**Fir Island Farm Estuary Restoration Project
Interior Drainage Engineering Report
Skagit County, Washington**

November 7, 2014

Submitted To:
Mr. Brian Williams
Washington Department of Fish and Wildlife
111 Sherman Street
LaConner, Washington 98257

**FIR ISLAND FARM ESTUARY RESTORATION PROJECT
FINAL DESIGN AND PERMITTING
INTERIOR DRAINAGE ENGINEERING REPORT
SKAGIT COUNTY, WASHINGTON**

<p>Fir Island Farm Estuary Restoration Project Skagit County, Washington</p>	
<p>PROJECT SITE PLAN</p>	
<p>NOVEMBER 2014</p>	<p>21-1-12318-216</p>
<p>SHANNON & WILSON, INC. <small>GEOTECHNICAL AND ENVIRONMENTAL CONSULTANTS</small></p>	<p>FIG. 1</p>

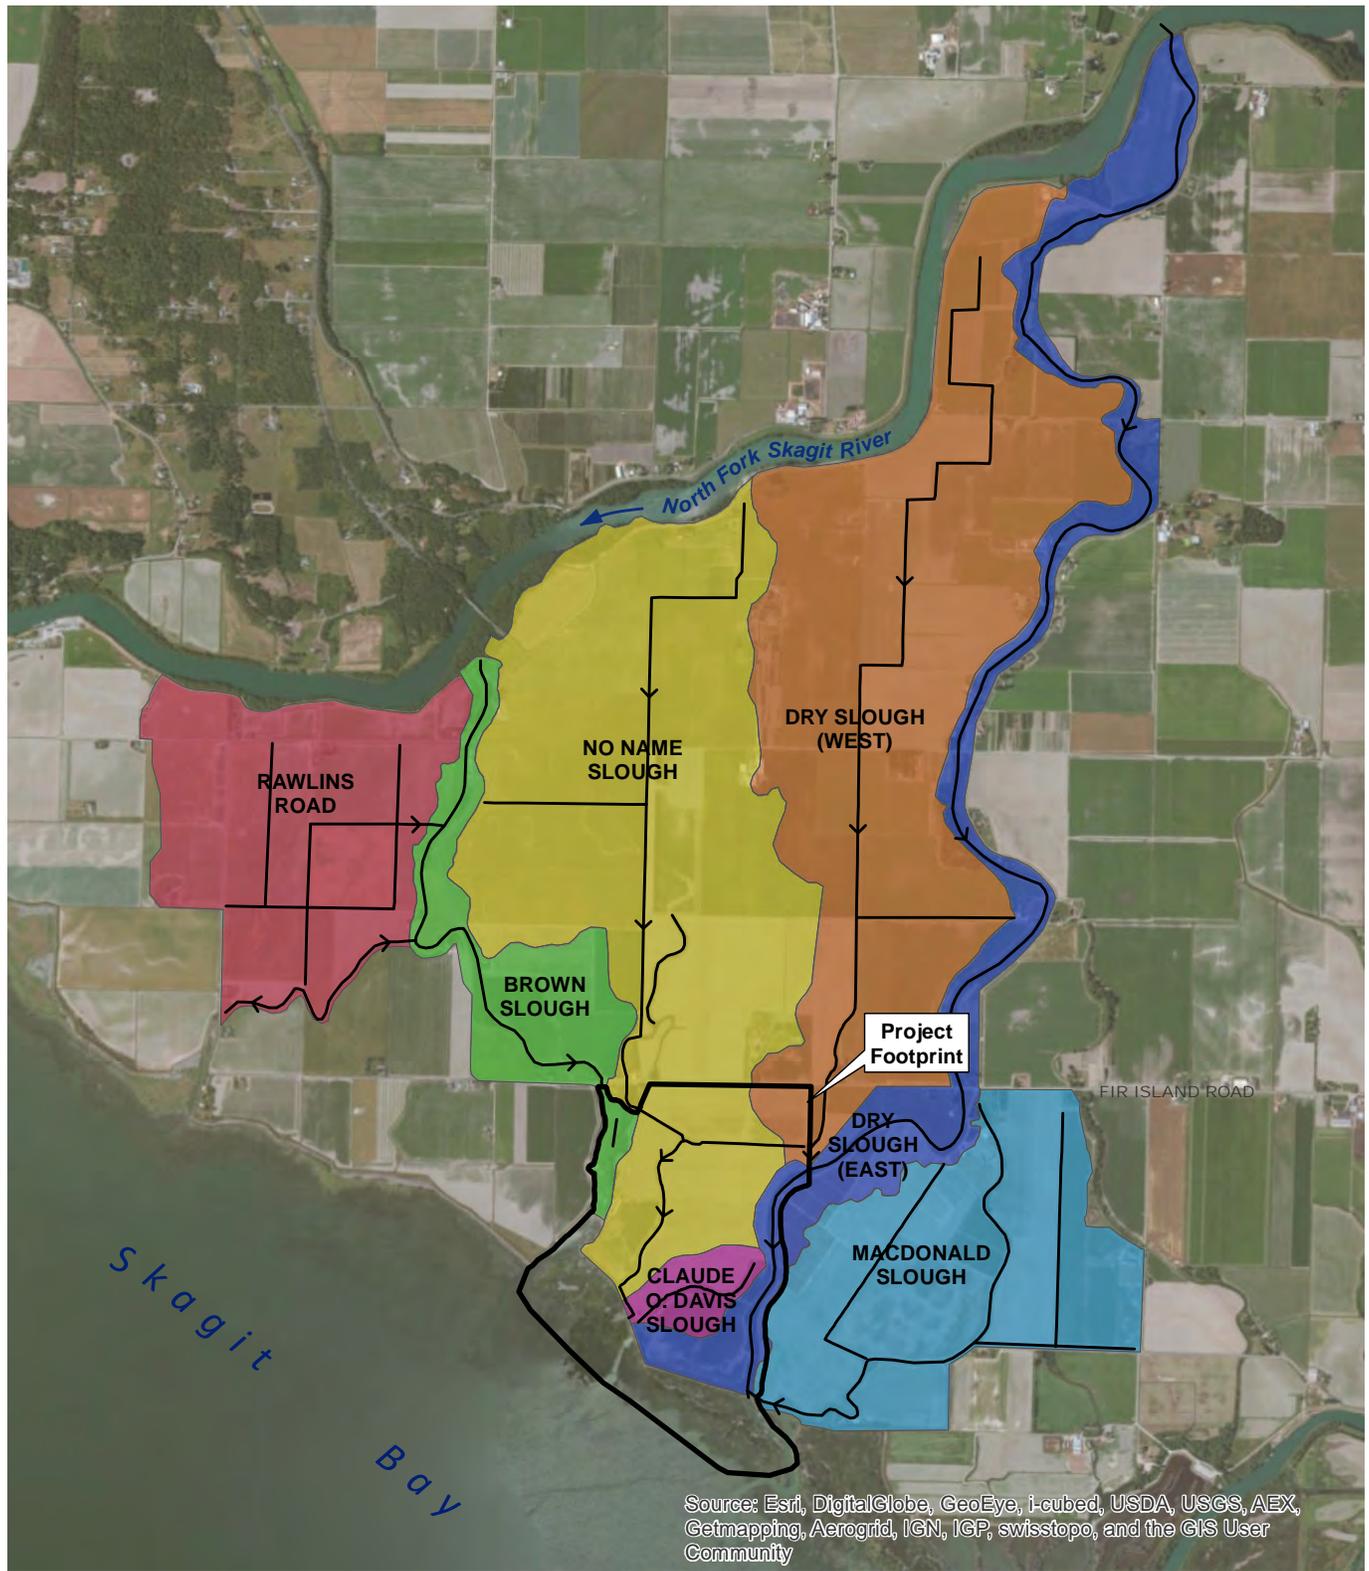
18	Draft Interior Drainage Engineering Report, February 26, 2014	Figure 1 Project Site Plan	D. Ladd	Would be helpful to more clearly identify "Dry Slough" (text appears faded). Also McDonald Slough is not obviously identified.	DRC	Corrections made.	
19	Draft Interior Drainage Engineering Report, February 26, 2014	Appendix B	D. Ladd	Overall it is very time consuming to confirm the modeling layout, assumptions, inputs, etc. in part because of inconsistent labeling. Given that the diking district (CDD22) has questioned the seepage rates, clarity of presentation is important.	DRC	Revised labeling on Figures B-2 through B-11 to use consistent terminology.	
20	Draft Interior Drainage Engineering Report, February 26, 2014	Appendix B, B-1 Page B-1	D. Ladd	Editorial - Wells are variously identified as B-4w-13 (note lowercase w) and B-5W-13 (caps). IDs in text should be consistent with well IDs in data report (cap "W")	DRC	Corrections made.

6	same	Figure 1	Susan Tonkin	It would be helpful to have a figure that shows existing grades	DRC	Overlaying LIDAR elevations on Figure 1.	
7	Draft Interior Drainage Engineering Report, February 26, 2014. Appendix A: Hydrological Monitoring	Section A.1.2.2, page A-4, paragraph 3	Susan Tonkin	Editorial: Change "nearly 1.0 feet lower" to "nearly 1.0 feet less" - "lower" sounds as though the groundwater surface is lower and it's actually higher. Similarly, the statement "the groundwater gradient is towards Skagit Bay" sounds as though seepage flows towards, not away from, the Bay.	DRC	Revised first comment to use the word "Less". Interior farm area groundwater gradient is towards Skagit Bay. Tidal groundwater gradient is towards the farms, only across the dikes, to the ditches on the backside. Two separate groundwater gradients converge in the ditches.	
8	same	Section A.1.2.2, page A-4, paragraph 3	Susan Tonkin	Observed conductivities in the Hayton South groundwater wells - presumably these are not the same as those observed in wells to the north, since the salinity is so much higher.	DRC	Revised this paragraph to better describe observed groundwater elevations and salinities and comparing Hayton North and Hayton South fields.

Fir Island Farm Estuary Restoration	
Skagit County, WA	
GROUNDWATER WELLS	
WDFW NORTH FIELD (B-4w-13 & B-5w-13)	
SALINITY	
JUNE 2013 - SEPTEMBER 2014	
November 2014	21-1-12318-216
SHANNON & WILSON, INC. GEOTECHNICAL AND ENVIRONMENTAL CONSULTANTS	FIG. A-4

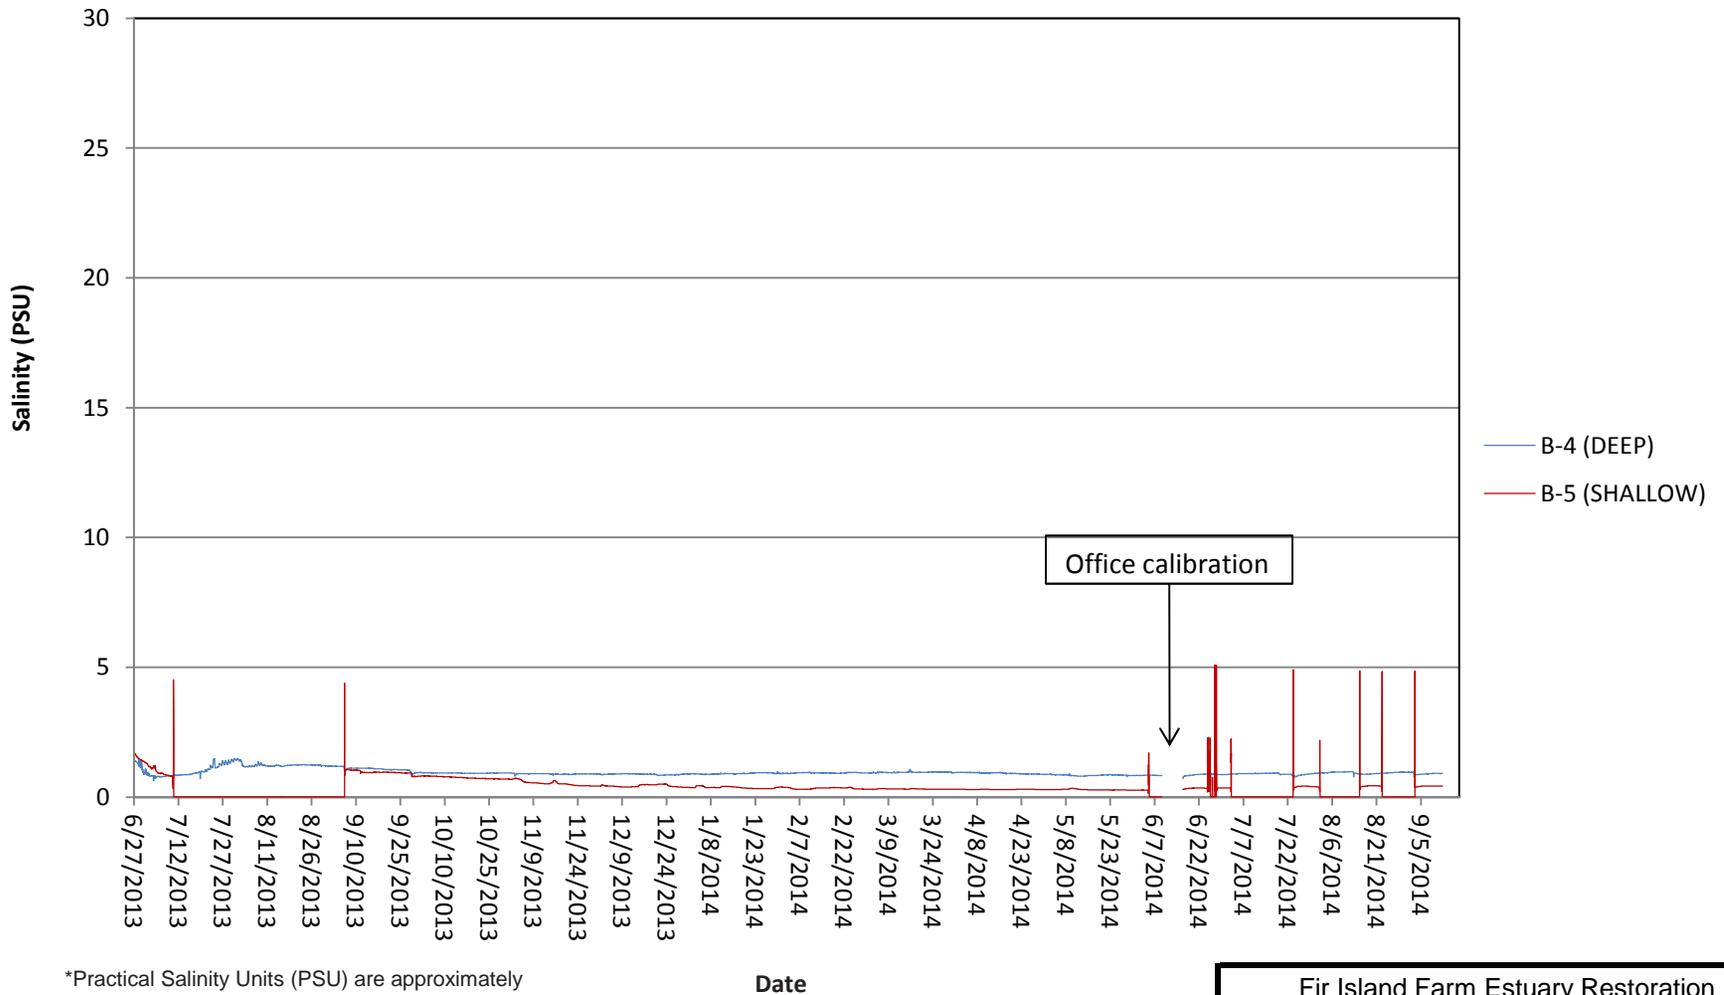
9	same	Figures A-1 to A-9	Susan Tonkin	Editorial: Could you add the field name (Hayton South, etc.) to these figures?	DRC	Field location names added to figures.	
10	same	Figure A-4	Susan Tonkin	The average at B-7 doesn't look like 3.47 - can you check this isn't the B-6 average?	DRC	Confirmed, average is calculated from B-7 data.	
11	same	Figure A-15	Susan Tonkin	Editorial: Could you mention the salinity gauge problems in the note here?	DRC	Data processing error. Corrected with most recent data downloads through Feb. 2014.	
12	same	Figure A-15	Susan Tonkin	Are there plans to replace the NNS-2.0 salinity probe, or do you think you have the information you need?	DRC	Data processing error. Corrected with most recent data downloads through Feb. 2014.	
13	Appendix B. Seepage Analysis	Section B.1.2, page B-2, last paragraph on page	Susan Tonkin	The 1 cfs is a very round number - can you provide a range on this?	DRC	A backcheck was performed and additional information added to Appendix B describing the range of observed seepage / baseflows to the existing ditch system.

Fir Island Farm Estuary Restoration Project Skagit County, Washington	
SEEPAGE MODELING ZONES	
November 2014	21-1-12318-216
SHANNON & WILSON, INC. <small>GEOTECHNICAL AND ENVIRONMENTAL CONSULTANTS</small>	FIG. B-2

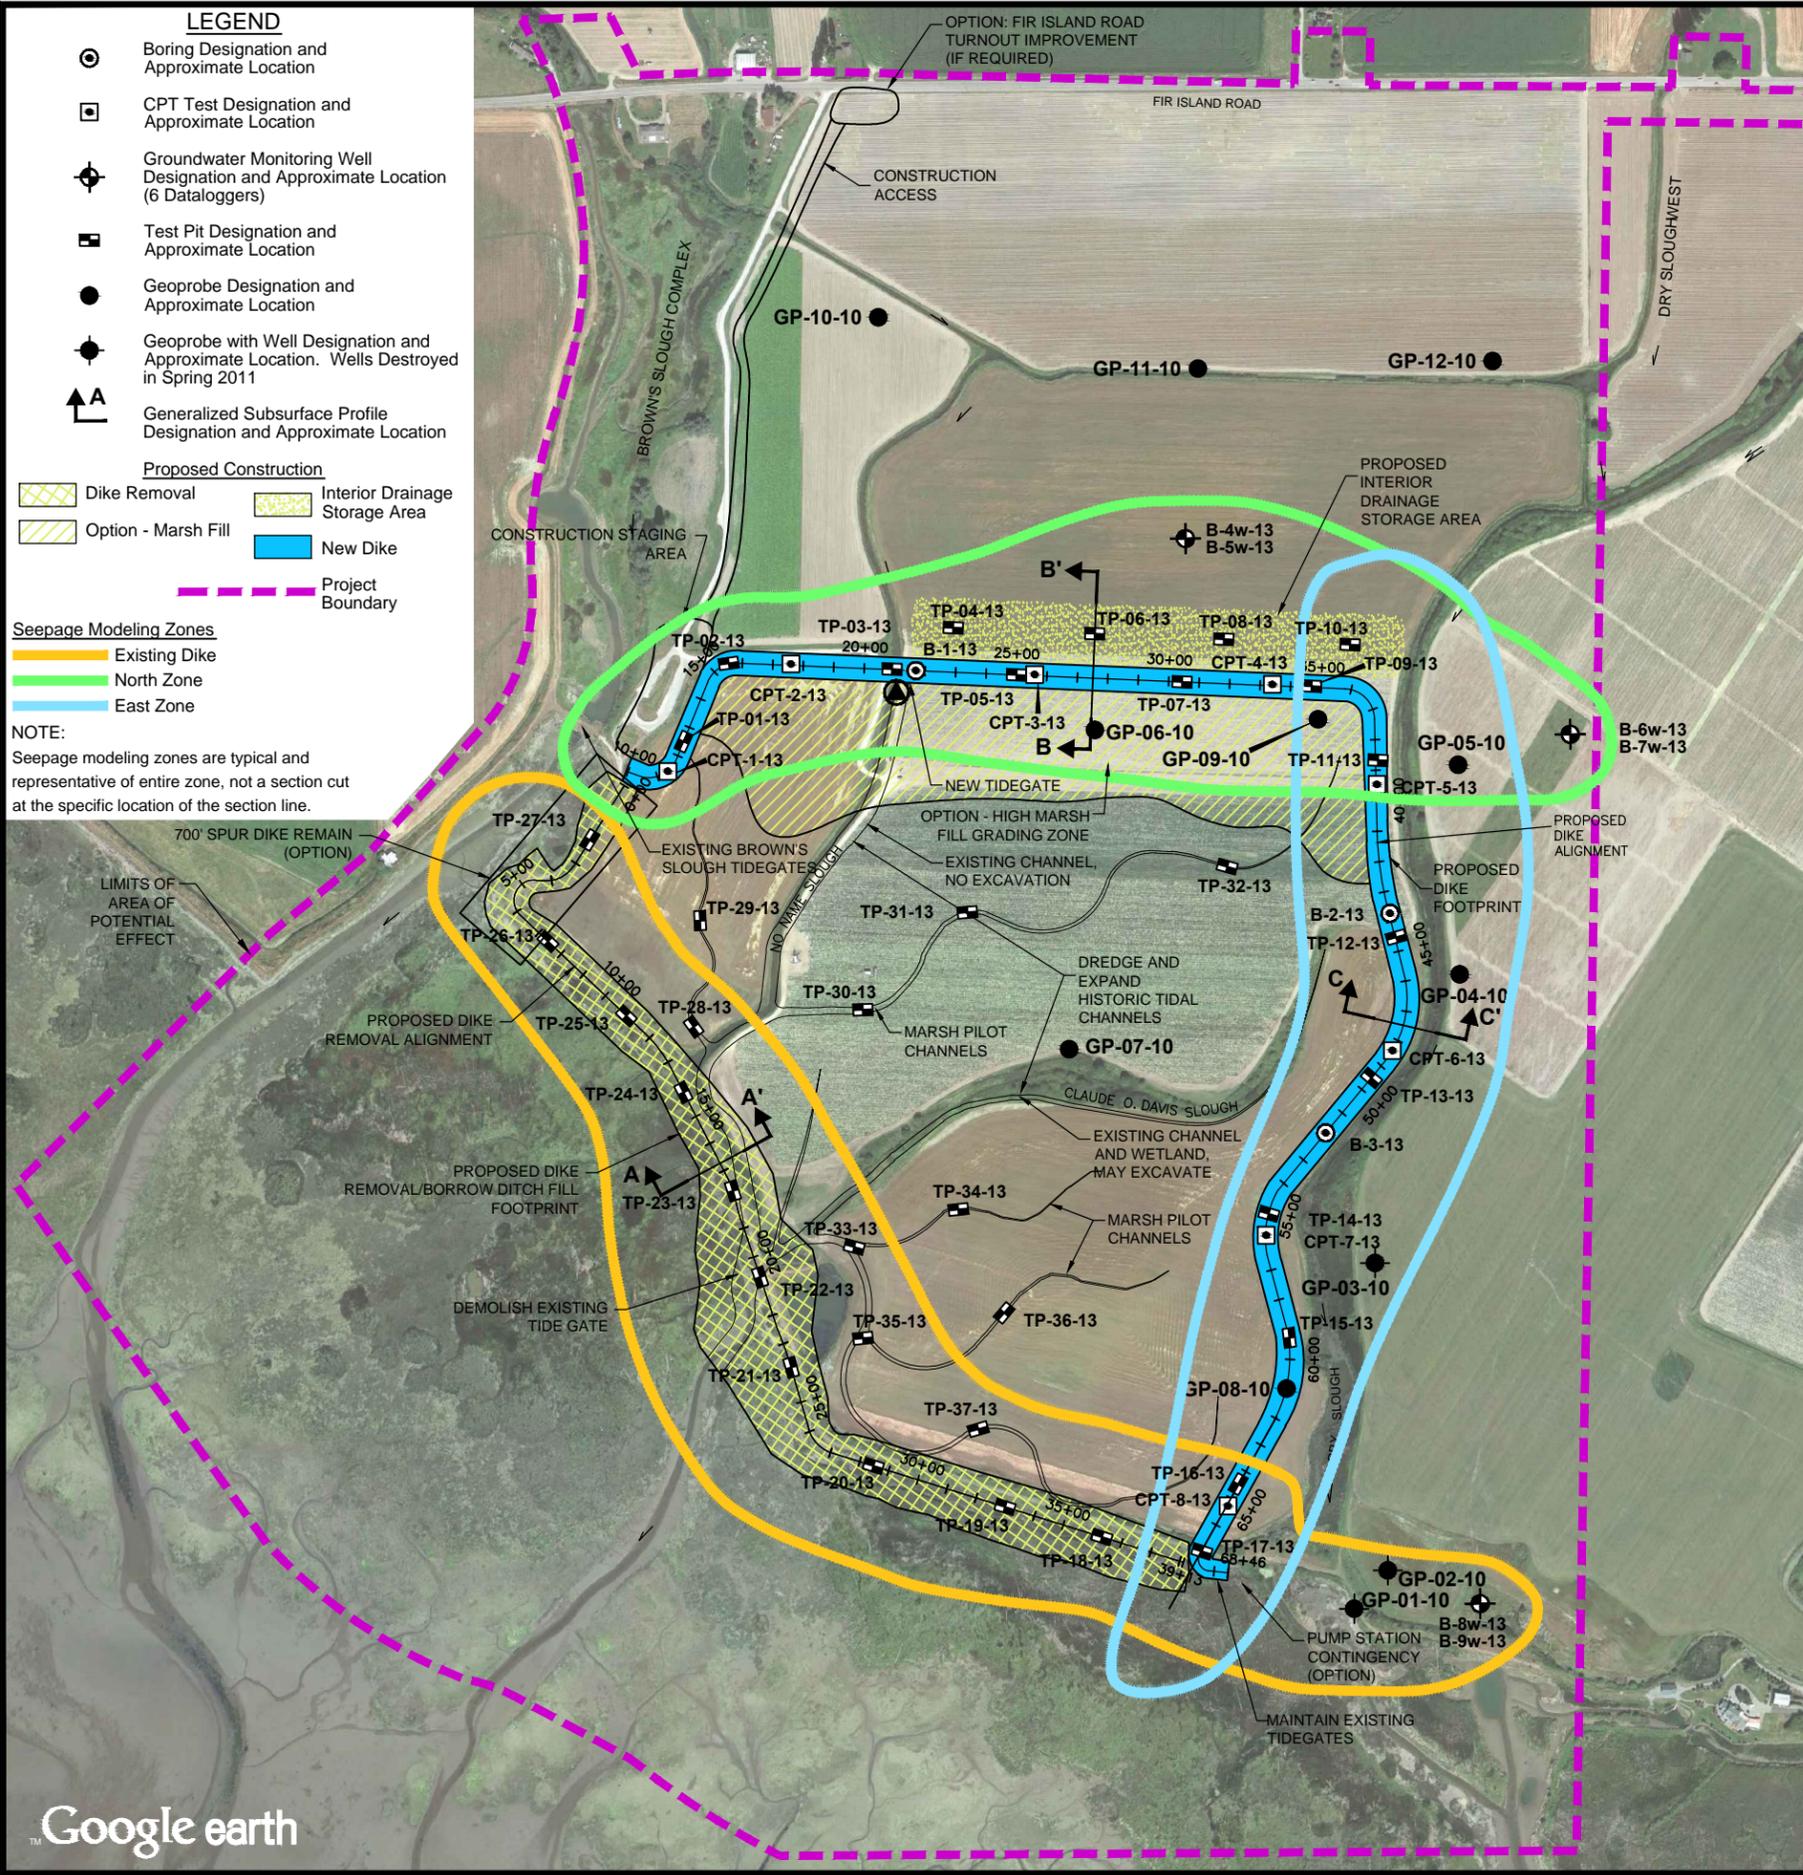
Owner		Washington Department of Fish & Wildlife					
Project		Fir Island Farm - Estuary Restoration Project, Final Design and Permitting					
Reviewer Name		Deb Ladd PE, LHg					
Reviewer Firm		Golder Associates					
Reviewer Email		dladd@golder.com					
Reviewer Phone		425 883 0777 (office) or 206 914 7825 (cell)					
Date of Review:		10-Apr-14					
No.	Report Name	Report Section, Page, Paragraph	Reviewer	Reviewer Comment	Responder	Responder Response	I TR Backcheck Complete
31	Draft Interior Drainage Engineering Report, February 26, 2014	Appendix B, B-1 Page B-3 and Figure B-1	D. Ladd	- The cross sections (A-A', B-B', C-C') are not referenced in the Appendix and should not be shown on this figure. - It would be helpful to add the locations of the modeled sections (Figs B-2, B-3, B-4) to this figure. - The identified zones are not clear on Figure B-1.	DRC	Figure B-1 is updated showing the typical sections.

32	Draft Interior Drainage Engineering Report, February 26, 2014	Figures B-2, B-3, B-4	D. Ladd	- The locations of the sections (even if 'typical') should be shown on Figure B-1 - Figure labels should include the "Zone" (or section ID) to help the reader locate the model section. - Acronyms should be explained (e.g. WSE, NNS). (Similar for B-5 through B-10.) - All figures should have similar titles so that the reader can compare the generalized section, to the model sections, and model results. - All units should be clearly identified (e.g., is flux in cfs per linear ft?)	DRC	Relabeled Figures B-2, B-3, B-4.	
33	Draft Interior Drainage Engineering Report, February 26, 2014	Figures B-5, 6, 7 and B-8, 9, 10	D. Ladd	Figures B-5, 6, 7 and B-8, 9, 10 should have similar names as Figures B-2, 3, 4 so reader can clearly match results to locations and conditions.	DRC	Relabeled Figures with similar names.

Fir Island Farm Estuary Restoration Project Skagit County, Washington	
SEEPAGE ANALYSIS TYPICAL SECTION PROPOSED NORTH ZONE STORAGE POND	
November 2014	21-1-12318-216
SHANNON & WILSON, INC. <small>GEOTECHNICAL AND ENVIRONMENTAL CONSULTANTS</small>	FIG. B-4

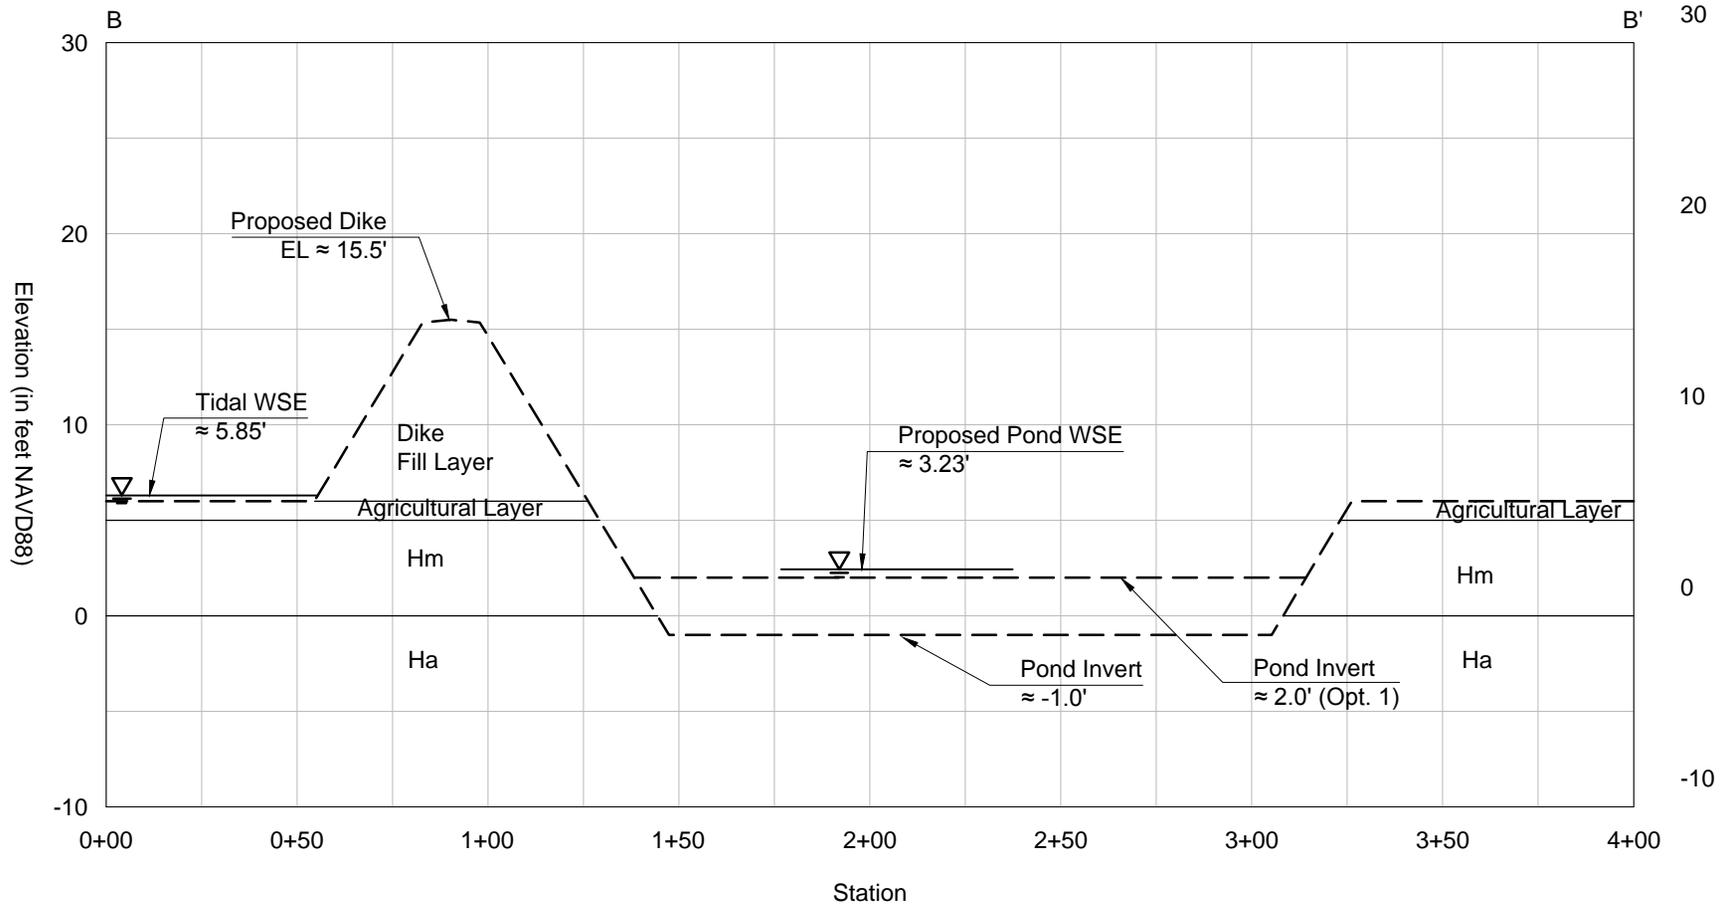
28	5/17/2014	Jenny Baker	Appendix B, fig. B-4	20-foot setback between setback dike and storage pond is not shown. Was this arrangement analyzed during seepage analysis? Would this change make a marked diff. in results?	SDT	Model seepage rates were analyzed using original 20ft setback for interior drainage seepage studies. A longer setback distance of 40ft from dike to pond will reduce seepage rates. However, the model uses seepage rates (1cfs ~450gpm) based on site monitoring data, and not the SEEP-W modeling estimates. The pond modeling approach is therefore conservative.
29	5/17/2014	Jenny Baker	Appendix C, intro and s C.3.3	see comment 6	DRC	Main report describes why April is the "representative" worst case condition due to high groundwater levels, higher surface water flow rates, and farmers needs to work fields for summer crop planting.
30	5/17/2014	Jenny Baker	Appendix C, p. c-3	last paragraph - discussion of landuse and runoff characteristics being the same in future as they have been 1948-2009. My understanding is that your analysis is for the Fir Island interior drainages only and does not incorporate river flood levels/dynamics and any changes that might occur there in the future. If that is true, does it need to be clarified here?	DRC	Provided statement that future changes in Skagit River flow and flood conditions were not considered.
